Bill No. 12R-281

FACTSHEET

TITLE: **SPECIAL PERMIT NO. 06001B,** requested by Fox Hollow, LLC, for authority to amend the **Grand Terrace Community Unit Plan** to add 4.6 acres and up to 31 additional dwelling units, on property generally located at South 84th Street and Amber Hill Road.

LINCOLN/LANCASTER COUNTY PLANNING STAFF REPORT

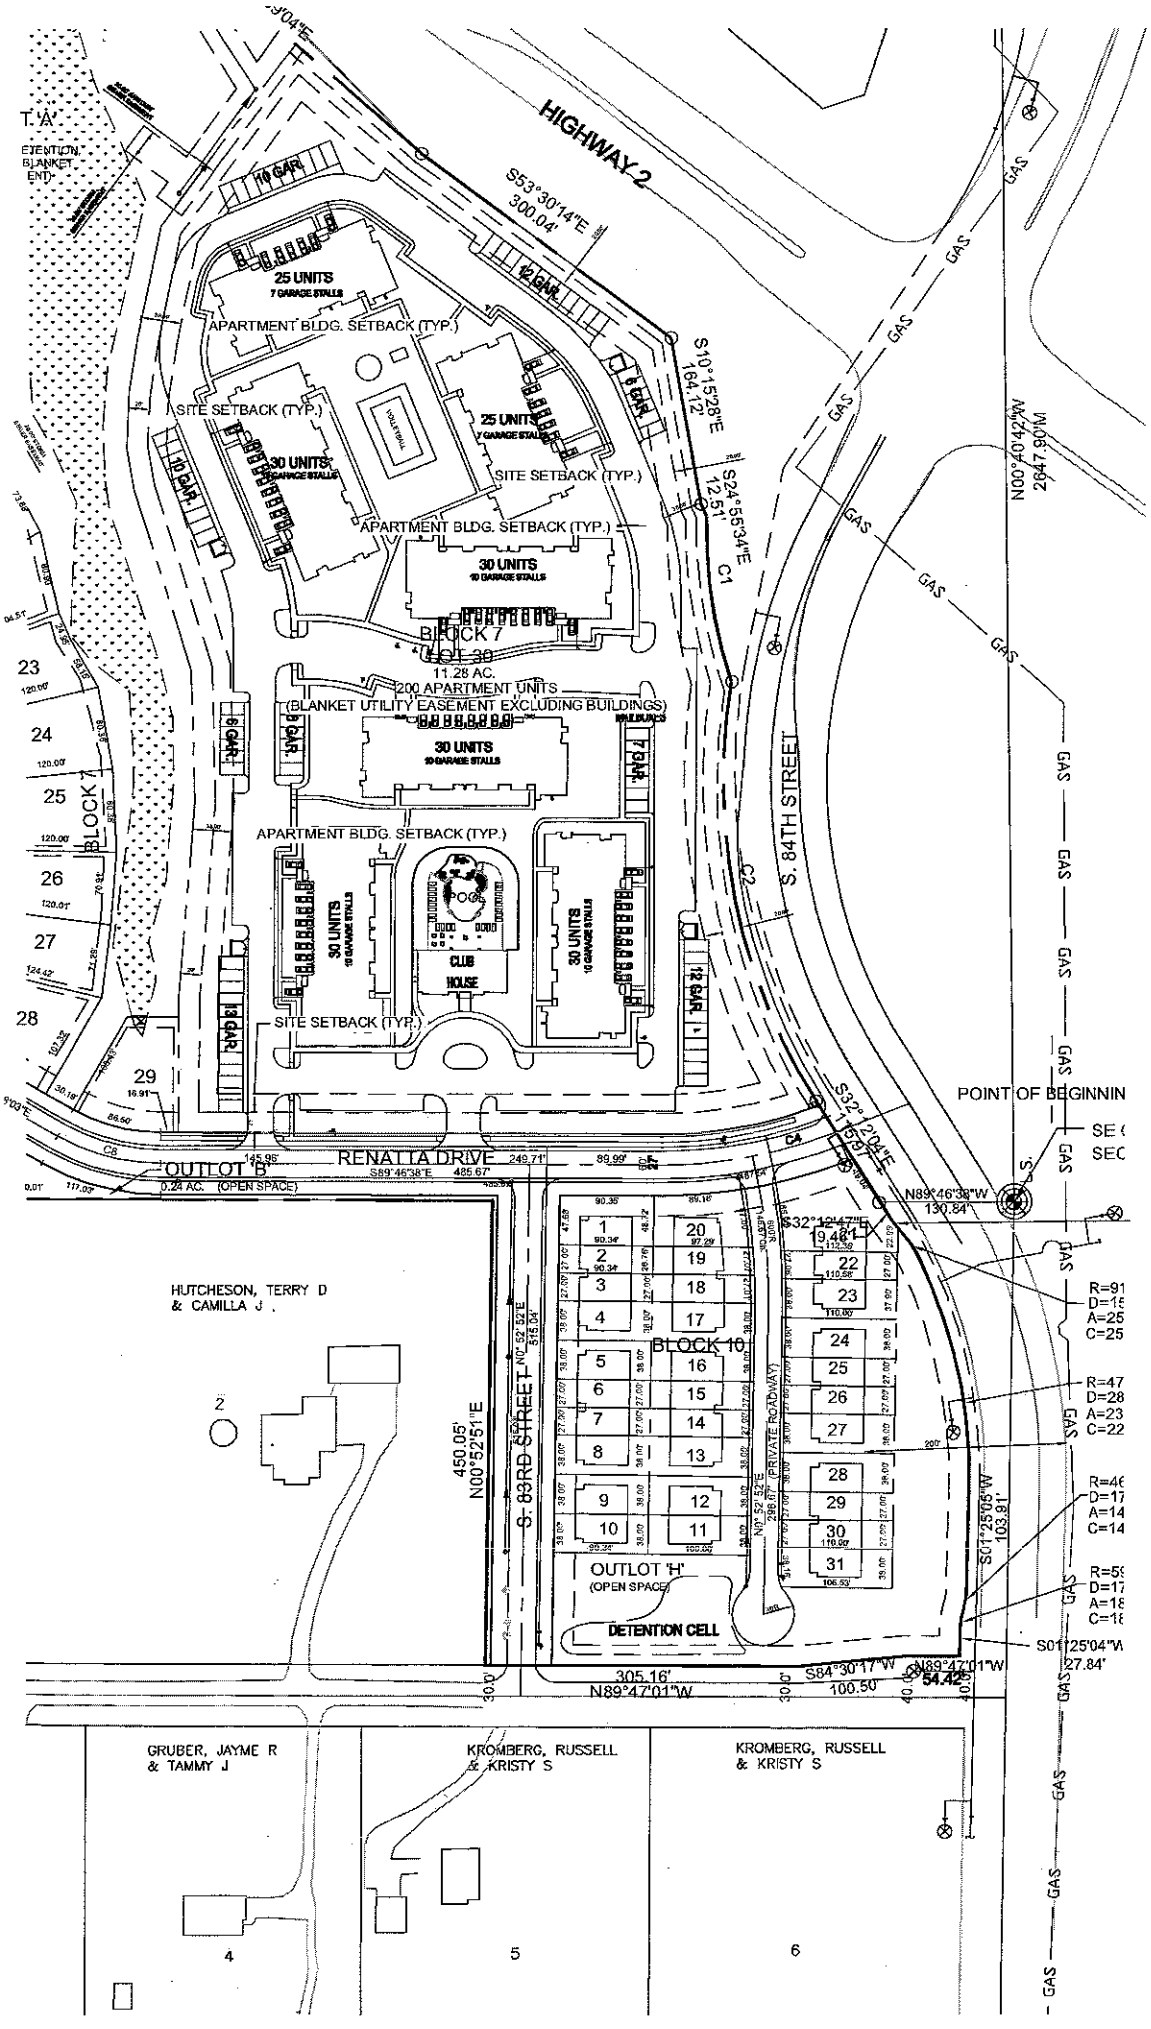
i. Revise General Note #12 to include the correct lots. Lots 16-20, Block 2, and Outlot G are not correct.

ii Delete General Note #14.

iii. Add General Note #24 which states, "Signs to be reviewed at the time of sign permit in accordance with the requirements of LMC Title 27."

iv. Revise the Waivers Table by: Deleting Waiver #4; adding the waiver to cul-de-sac radius from 43.5' to 30'; and noting which blocks Waivers #2 and #3 apply to as previously approved.

v. Revise the apartment site layout by removing the detail shown and instead including the building and setback envelopes, and the number of units approved per AA#12028.

vii. Show required right-of-way to be dedicated as noted by Public Works and Utilities.

viii. Show a pedestrian sidewalk connection from South 83rd Street to South 84th Street along the north edge of the detention cell through the cul-de-sac bulb or from the private roadway to Amber Hill Road.

ix. Add a general note which states, "The garage for the dwellings facing the private roadway shall be set back 22' from the back of the sidewalk. The sidewalk should be at least 8' from the curb along the private roadway.

6. In their comments the Health Department noted an underground, high-pressure gas pipeline located near the centerline of South 84th Street. The Health Department's calculated hazard area is 221' either side of the pipeline. In response to this concern the applicant revised the site plan during the review process by moving the detention to the south edge of the site, and by leaving open space along South 84th Street. The arrangement was intended to maximize the separation between the pipeline and the dwellings, which is now shown to be approximately 200'.

Review Comments		
Planning	(●) Corrections Needed for Review ( ) Insufficient Information for Review ( ) Recommend Denial ( ) Recommend Approval with Conditions ( ) Recommend Approval ( ) No Review Required Review 1:	
County Health (Chris Schroeder)	( ) Corrections Needed for Review ( ) Insufficient Information for Review (●) Recommend Denial ( ) Recommend Approval with Conditions ( ) Recommend Approval ( ) No Review Required Review 1: According to the Lincoln-Lancaster County Health Department's (LLCHD) Geographic Information System (GIS) records, a high pressure underground natural gas pipeline is located adjacent to the eastern edge of this proposed development underneath South 84th Street. The LLCHD calculated a hazard area of approximately 221 feet on each side for this pipeline using the hazard area equation from report entitled, "A Model for Sizing High Consequence Areas Associated with Natural Gas Pipelines" prepared by Mark J. Stephens from C-FER Technologies. A hazard area or high consequence area is defined as the area within which the extent of property damage and the chance of serious or fatal injury would be expected to be significant in the event of a worst case scenario rupture failure. According to the V2 site-plan provided by the applicant, only approximately 160 feet is provided between the pipeline and the proposed town homes which locates town homes 23-32 within the projected hazard area. The LLCHD will not support developments that locate occupied dwellings within hazard areas. This agrees with the final report submitted by the Planning Commission and Board of Health Joint Committee on Health and Land Use which recommended that, in new developments, developers should avoid the Hazard Area as much as possible.

Public Works (Dennis Bartels)	○ Corrections Needed for Review ○ Insufficient Information for Review ○ Recommend Denial ◉ Recommend Approval with Conditions ○ Recommend Approval ○ No Review Required Review 1: The CUP information is incomplete and will require a full set of plans to be approved prior to final plats and construction of the townhouses shown. The following are a list of comments, concerns and requirements based upon the incomplete submittal. Additional comments and concerns may be raised when a complete set of plans meeting subdivision and special permit requirements is submitted for review. 1. S 84th Street adjacent to this development is a major arterial. Right of way must be dedicated to provide 60' of right of way west of the pavement centerline and 70' of right of way for a right turn lane for Amber Hill Road for a turn lane that meets requirements of the Access Management Policy. 2. Amber Hill Road needs to be paved to an urban cross section curb and gutter street. This should include standard grading of the north half of the right of way. Potentially the south half grading can be substandard and the full grading to occur when the south half develops. This concept needs to be shown on the yet to be submitted grading and drainage plans. The plans as submitted show a corrugated culvert pipe beneath Amber Hill Road which will likely need to be replaced with concrete pipe to meet design standards. 3. Sidewalk are required along both sides of 83rd Street, the unnamed private roadway, the south side of Renatta Drive and the north side of Amber Hill Road. Sidewalks in easements should be built to 84th and 83rd Streets east and west of the south side of the unnamed private roadway. 4. The 30' diameter culdesac turn around at the south end of the private road is satisfactory to Public Works provided that parking is prohibited. 5. The utility plans are incomplete and cannot be fully reviewed. Sewer mains flowing opposite the street grades are satisfactory provided the depth of any portion of the pipe does not excede 15 feet and the minimum depth of the pipe is satisfactory to Public Works. This information is not provided. The required water main is not shown in Amber Hill Road. I also recommend the water main in the dead end private road be extended to the required main in Amber Hill Road to eliminate the dead end. 6. No grading and drainage plan including storm water detention has been

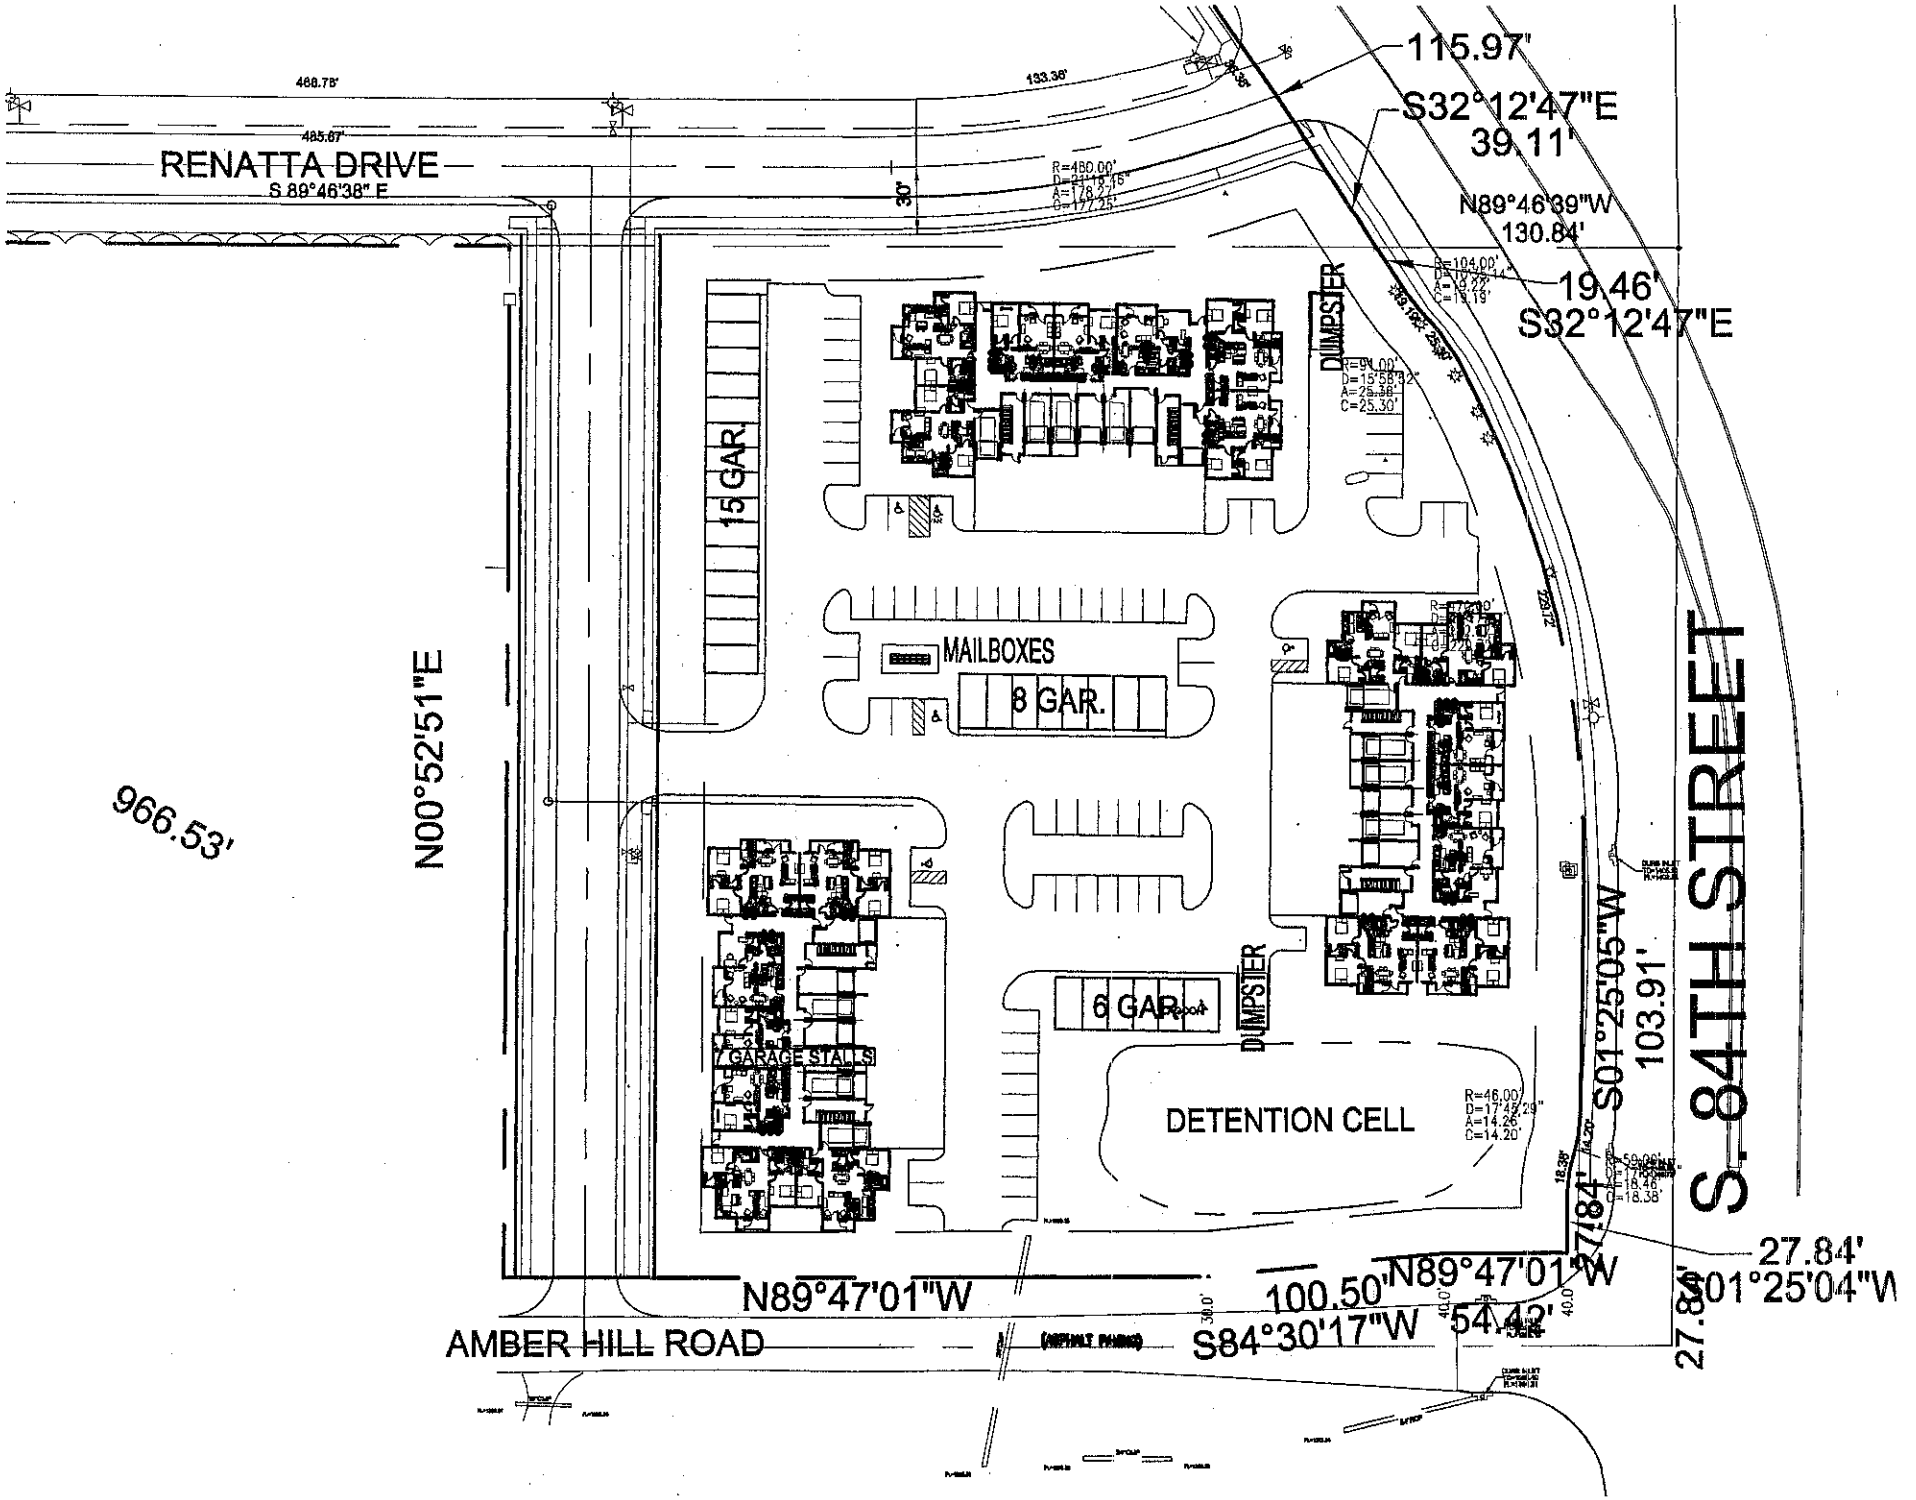
We understand the this area will develop in the near future but I do not believe this is the right plan. There needs to be an access point to this development from the north to alleviate the traffic burden at 84th and Amber Hill. If 83rd St does get put

in it needs to move to the east so it is not in line with our existing driveway. The way the plan is now the majority of the of traffic from this entire CUP will be exiting down 83rd St. and there will be traffic from approximately 200 home, apartments and town homes coming down 83rd street directly into our driveway. I would propose that 83rd street be moved to the east so that is does not line up with our existing driveway.
